# UNITED STATES PATENT AND TRADEMARK OFFICE

10/538,296

Minehiro Tonosaki

<b>Office Action Summary</b>	<b>Application No.</b> 10/538,296	<b>Applicant(s)</b> TONOSAKI ET AL.	
	<b>Examiner</b> LEONARD LEO	<b>Art Unit</b> 3785

FIG. 2

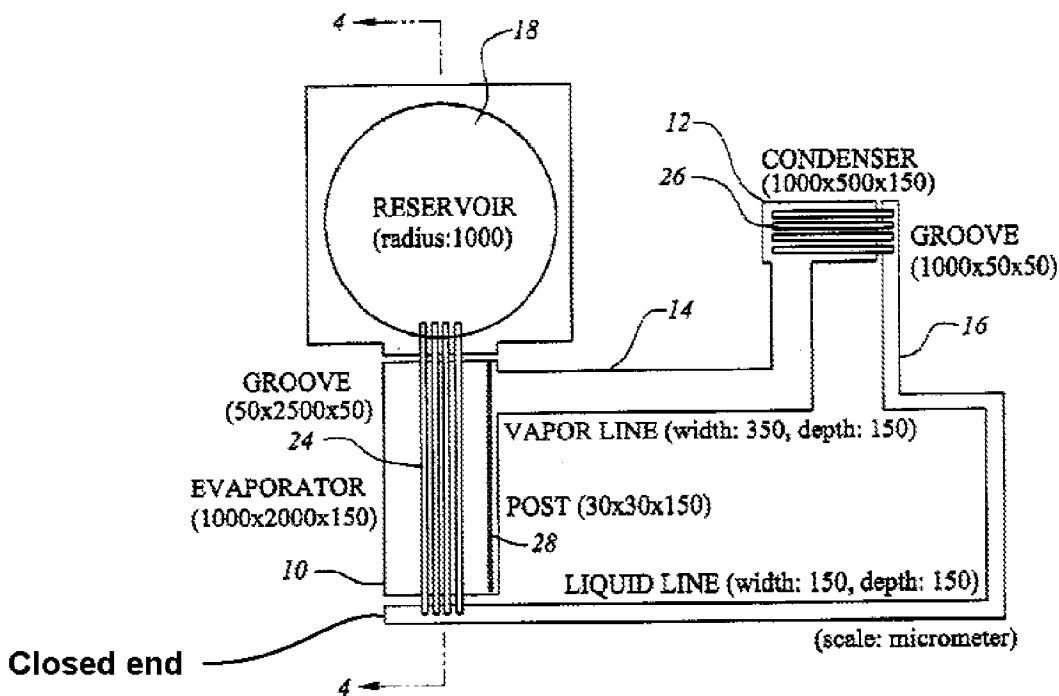
Kirshberg et al (Figure 3) discloses a heat transport device comprising:

a first base plate 22 including a liquid suction and retention unit in the forms of grooves 24; a body with protrusions formed by grooves 26;

a second base plate 21 including a face with a first concavity 10, a second concavity 12, a first ditch 14 forming a channel between the first and second concavities 10, 12, and a second

ditch 16 forming a channel with a closed end (Figures 2 and 4A, marked up, below) between the second concavity 12 and the liquid suction and retention unit;

but does not disclose resin bonding the base plates, the first base plate covered with a protective film, nor a third concavity on the second base plate.

FIG. 4A

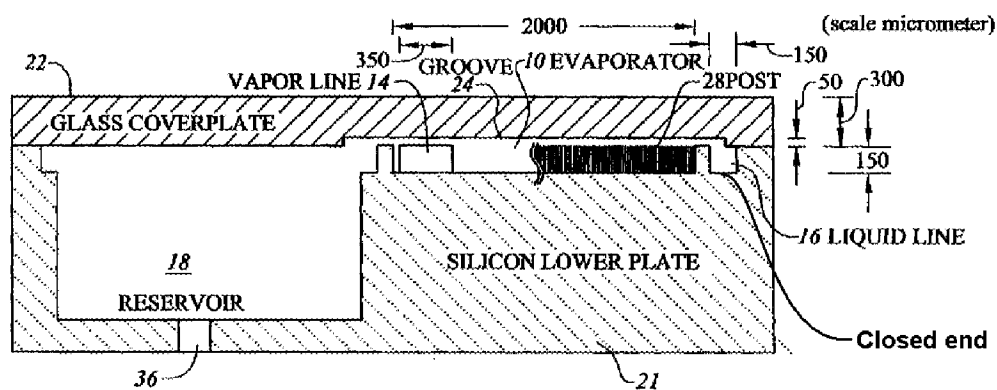
Regarding claim 18, Figure 4A discloses the first base plate 22 is disposed above the second base plate 21.
